STATE OF NORTH CAROLINA
DEPARTMENT OF TRANSPORTATION

Subject: Request for Modification of Section 404 Individual Permit and Section 401 Water Quality Certification for the U-2579B Section of the Winston-Salem Northern Beltway, from US 158 to I-40 Business/US 421, Forsyth County, Division 9, WBS 34839.2.10

The North Carolina Department of Transportation (NCDOT) requests a Permit Modification for the Winston -Salem Northern Beltway Eastern Section from US 158 to I-40, B Section of the U-2579 TIP. This project is currently under construction.

PERMIT DRAWING MODIFICATION FOR SITE 23 AND 28

**OCTOBER 1, 2019
PERMIT DRAWING
SHEET 2 OF 10**

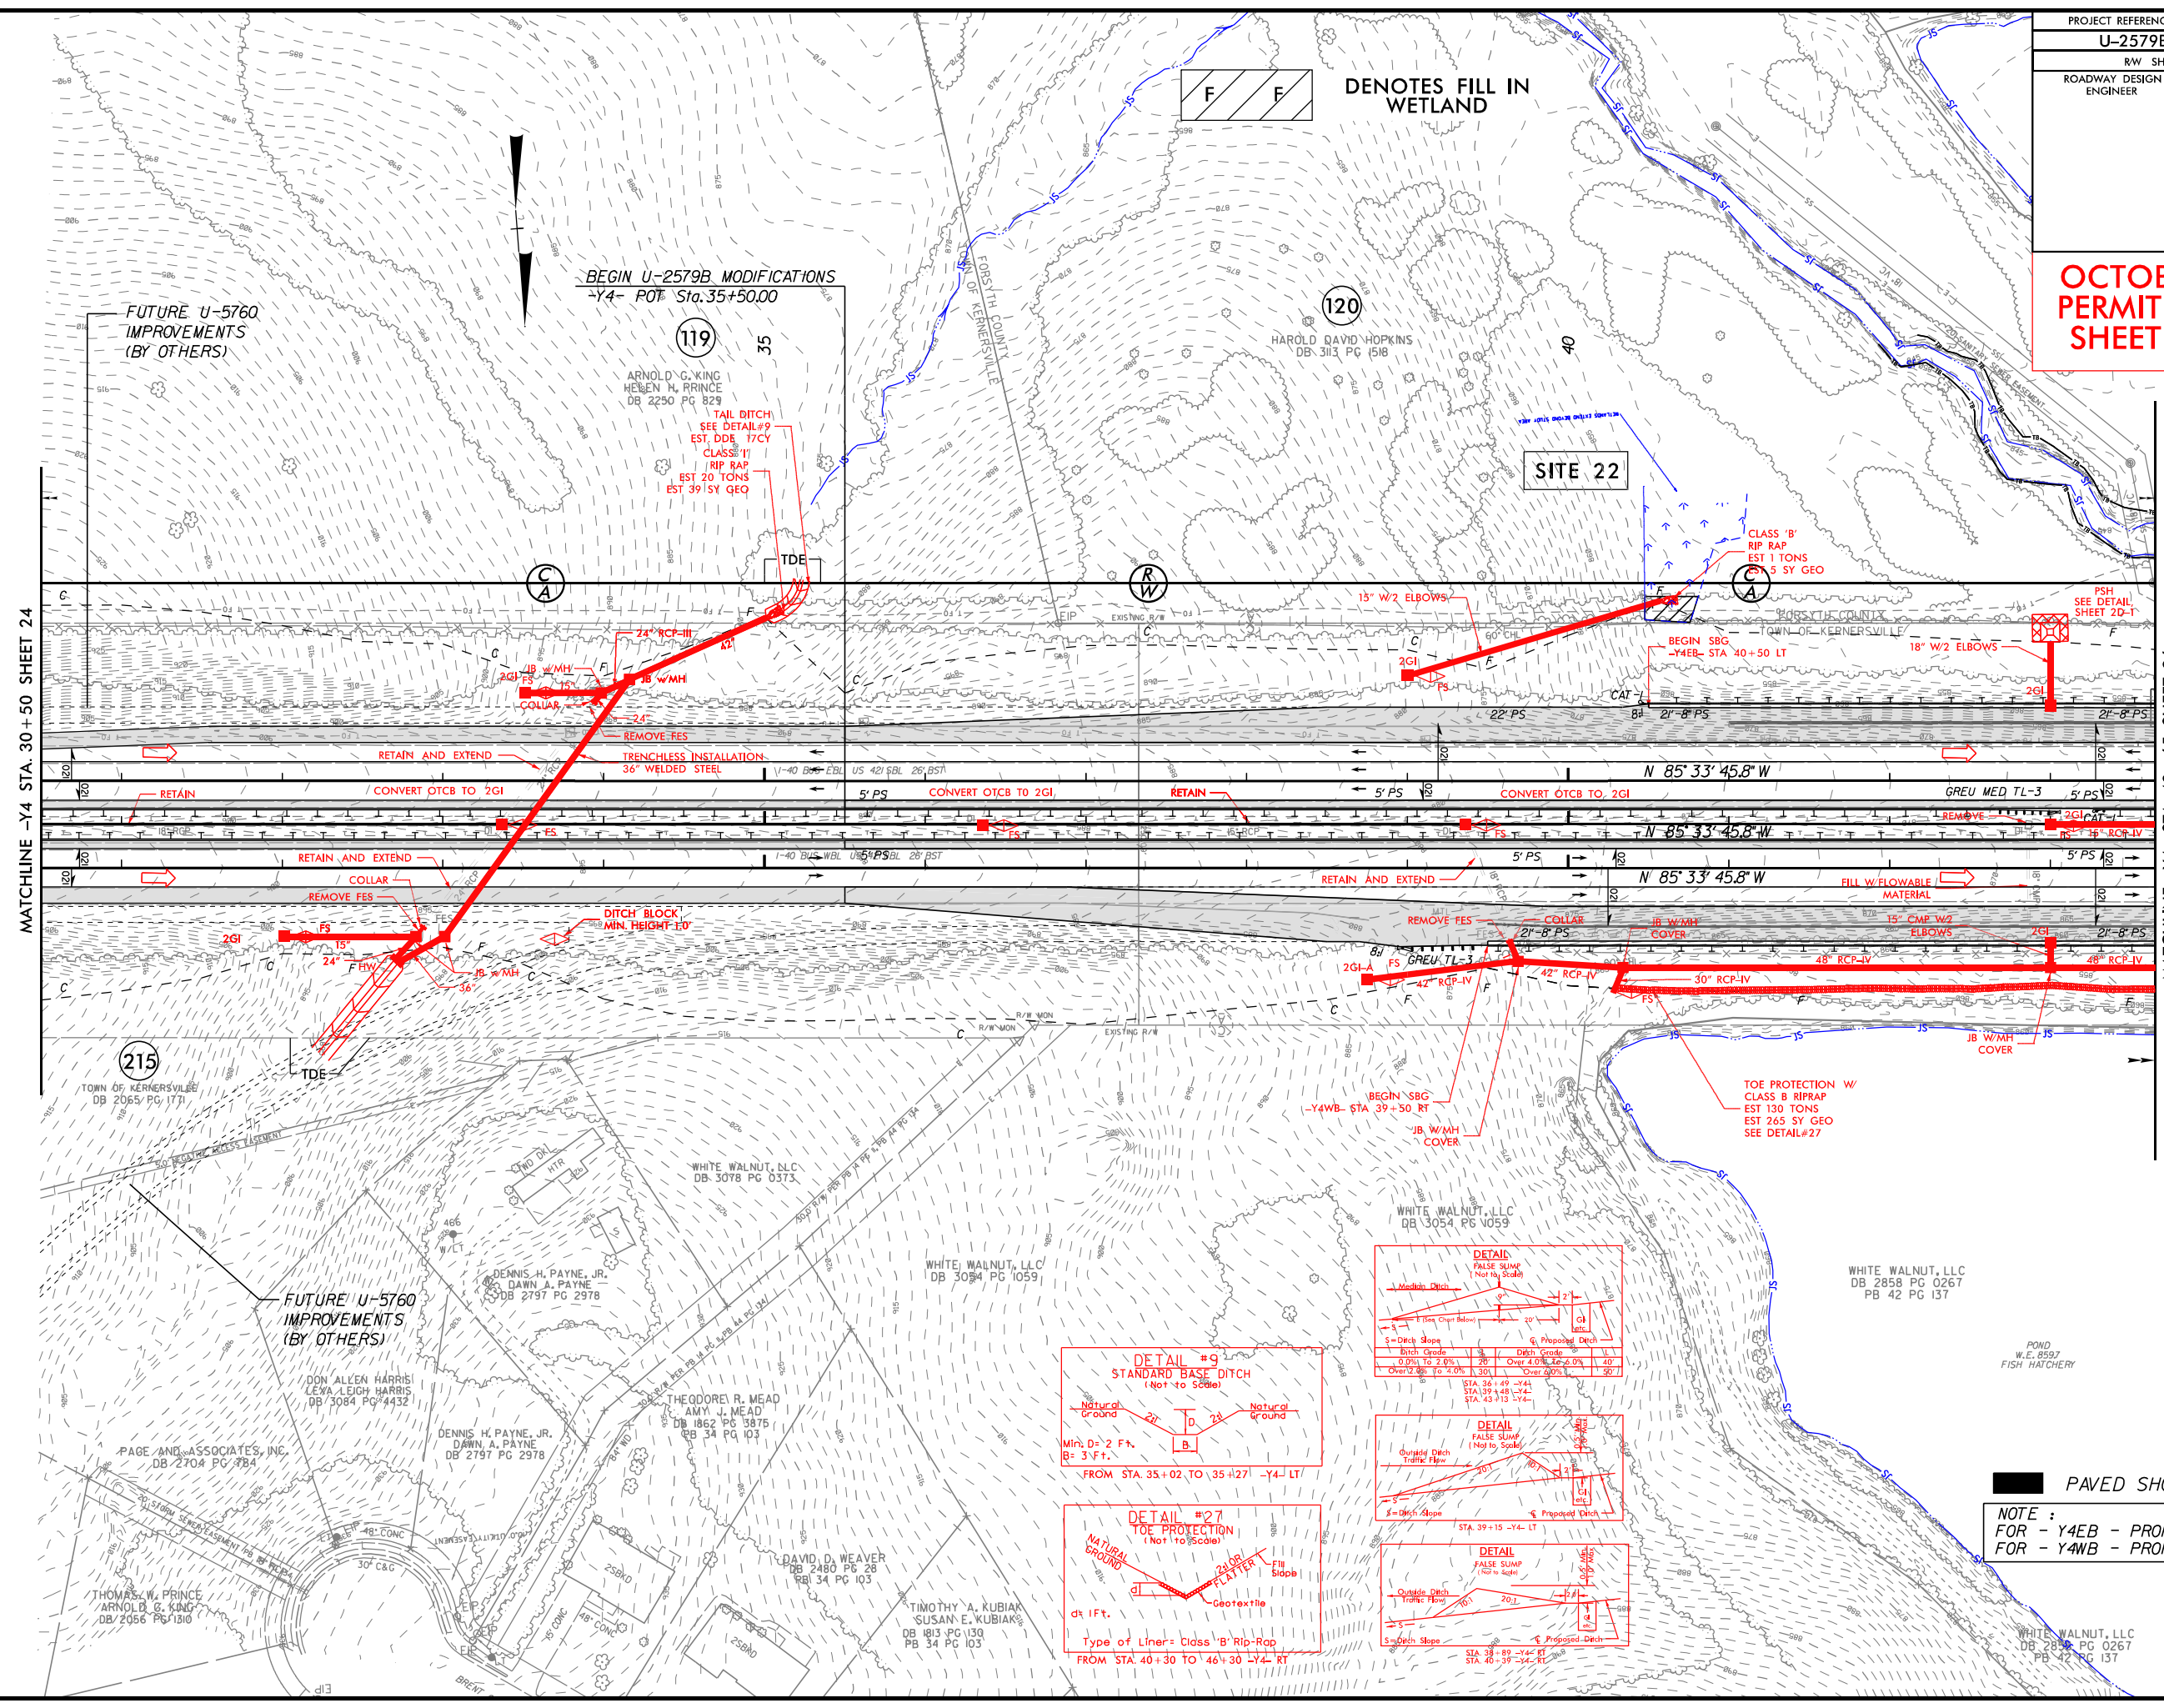
BEGIN U-2579B MODIFICATIONS
-Y4- POT Sta. 35+50.00

SITE 22

CLASS 'B'
RIP RAP
EST 1 TONS
EST 5 SY GEO

PSH
SEE DETAIL
SHEET 2D-1

OCTOBER 1, 2019 PERMIT DRAWING SHEET 3 OF 10

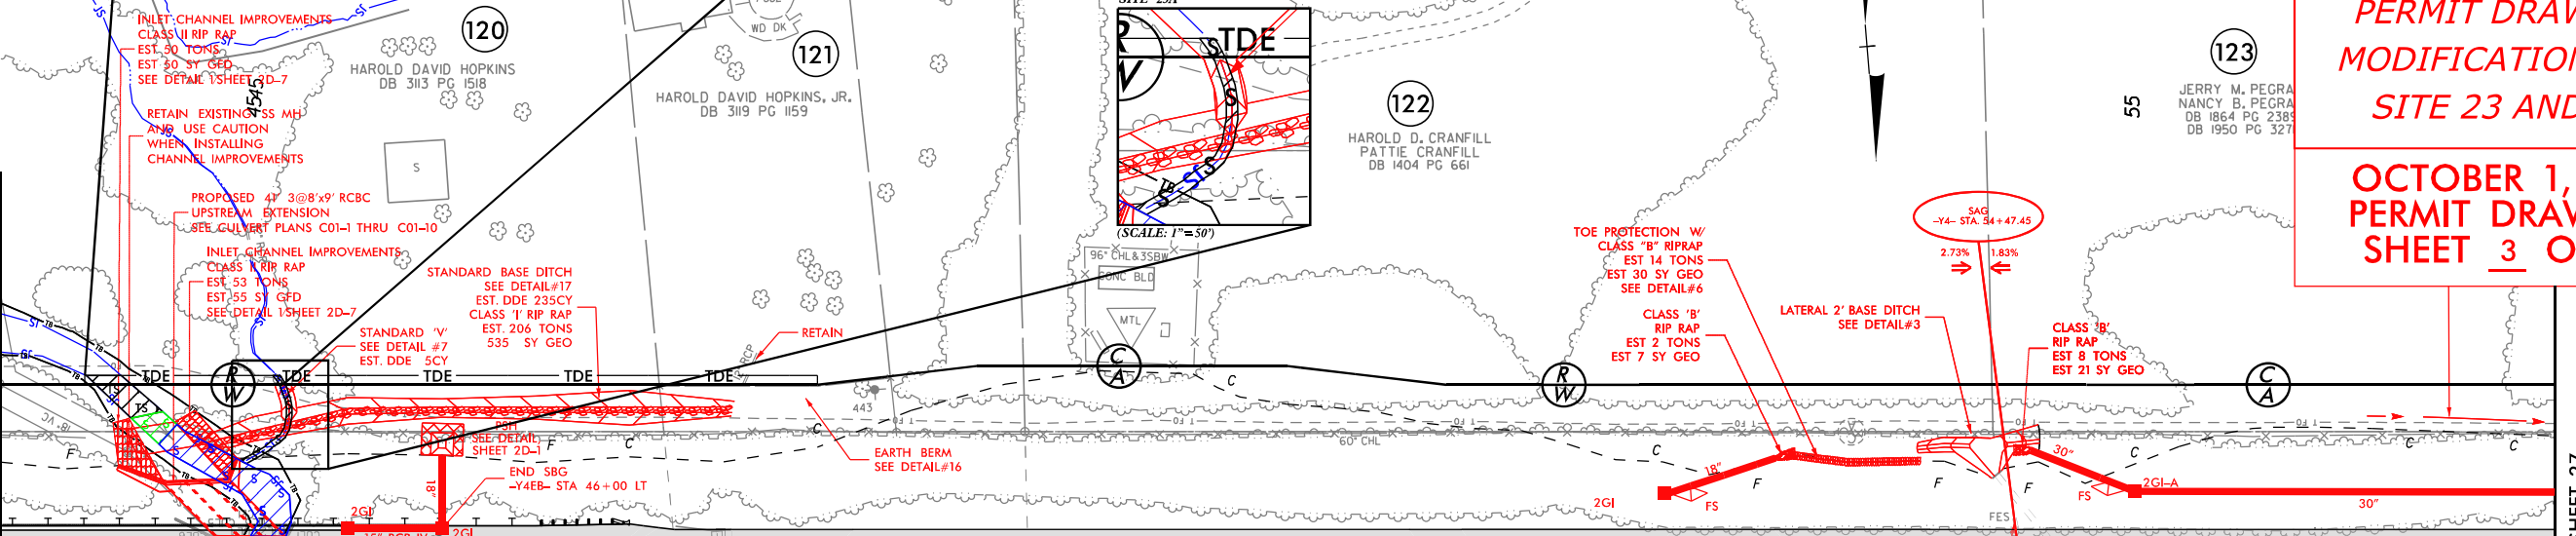
SITE 23 (PERMIT MOD)

SITE 23A

SITE 23B

SITE 23 (PERMIT MOD)

SITE 28A (PERMIT MOD)

SITE 28 (PERMIT MOD)

SITE 28C (PERMIT MOD)

SITE 28B (PERMIT MOD)

OCTOBER 1, 2019 PERMIT DRAWING SHEET 4 OF 10

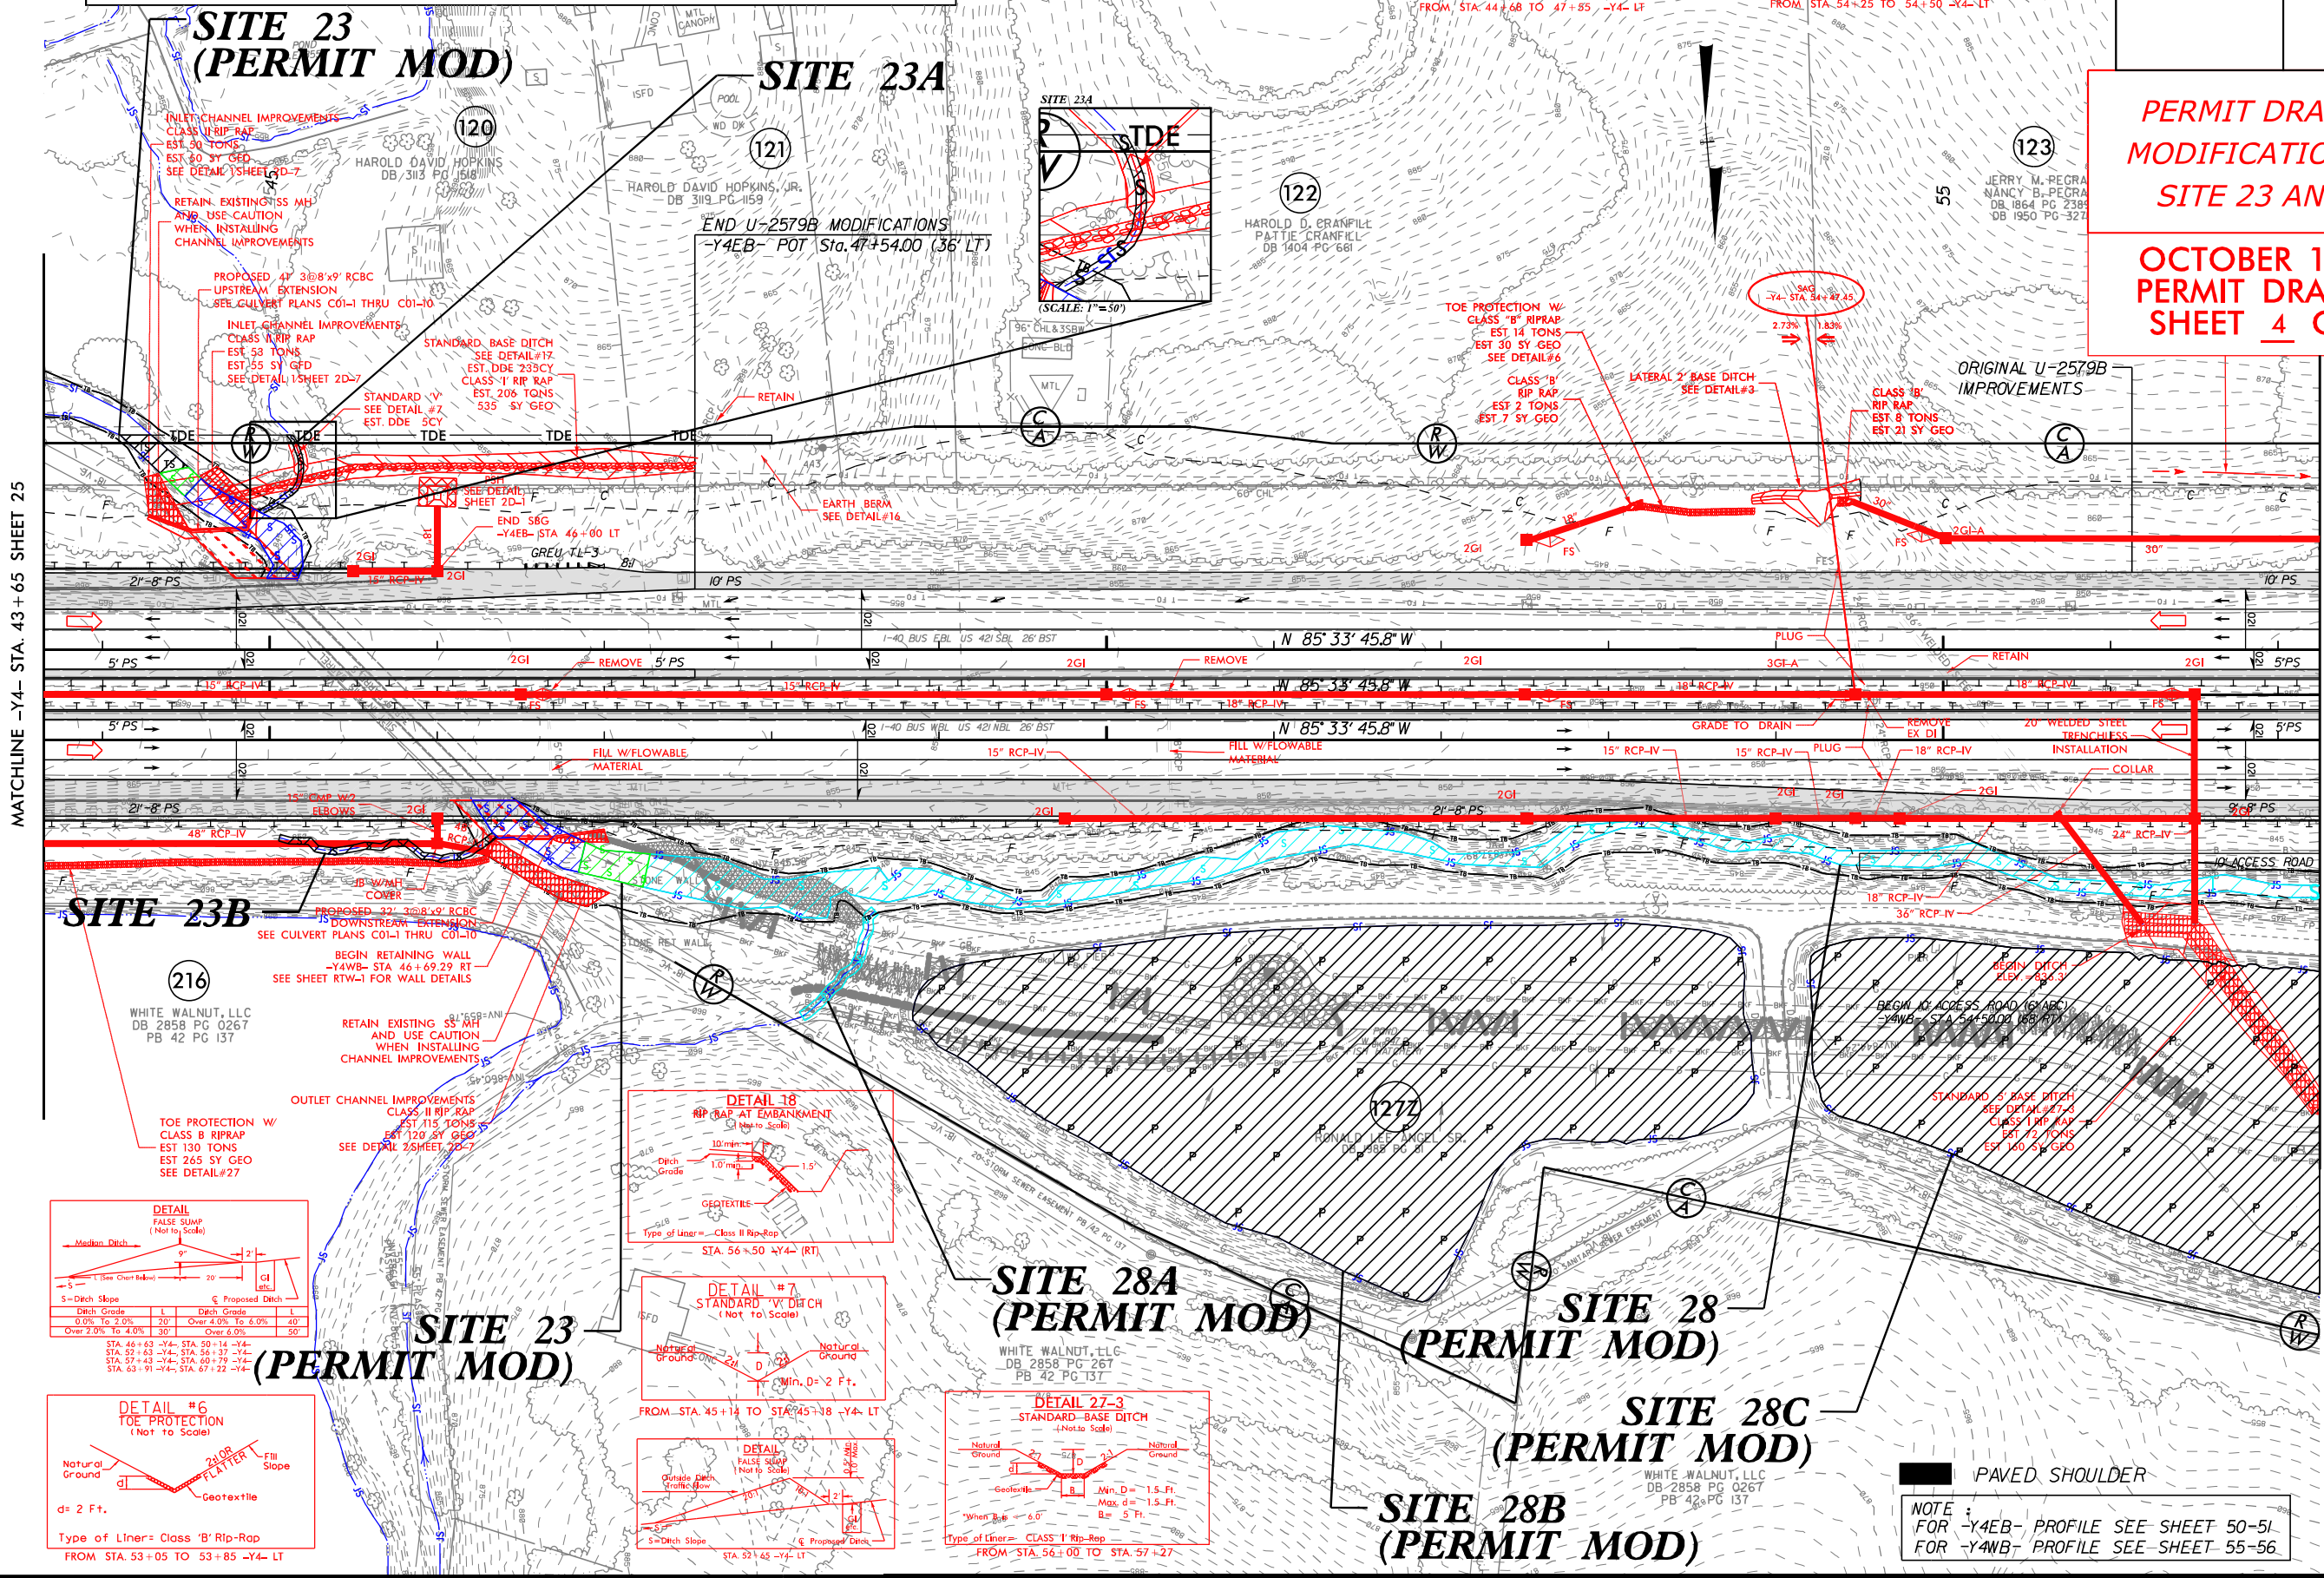
PERMIT DRAWING MODIFICATION FOR SITE 23 AND 28
